Peter & Christine Rose 361 Hanworth Road BANNABY NSW 2580

Director – Energy Assessments,
Development Assessment,
Department of Planning and Environment,
4 Parramatta Square,
12 Darcy Street,
Parramatta NSW 2150

SUBMISSION IN RESPONSE TO THE ENVIRONMENTAL IMPACT STATEMENT OF THE HUMELINK PROJECT – APPLICATION NO SSI-36656827

Map 1: Routes considered in the Bannaby area

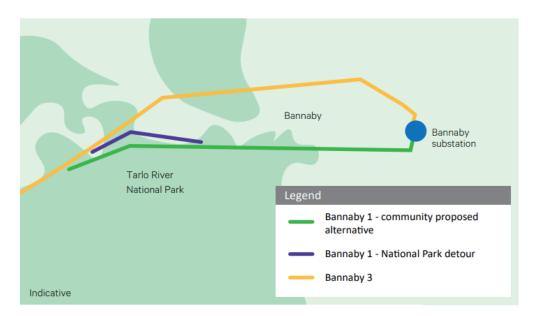
- 4.3. In around February 2021, we had our first "community consultation" with Transgrid at which time we were told the study corridor had changed, with the proposed route to cross the road to the north of the Bannaby substation, traverse directly through around (18) properties in the approximately 10 kilometres from the substation until it hooks back to the more direct route on the other side of Bannaby (Northern Route). This route does not keep the transmission lines as straight as possible, is not the shortest route between substations and does not parallel existing transmission easements.

- 4.4. There was no community consultation before the Northern Route was devised. It appears to have been done on a "desktop" basis with Transgrid later admitting it did not know the number of houses affected and that no one had driven (or even flown a drone) along the proposed route to visually assess the impact of the proposal on the local community. Considering the significant and devasting impact of the transmission lines on affected properties, community consultation should have started before the corridor was determined, not after. This is unacceptable in a modern democracy, particularly where Transgrid is a private company motivated by profit drivers.

- 4.5. The following map shows the Southern Route (in green) and the Northern Route (in yellow):⁸
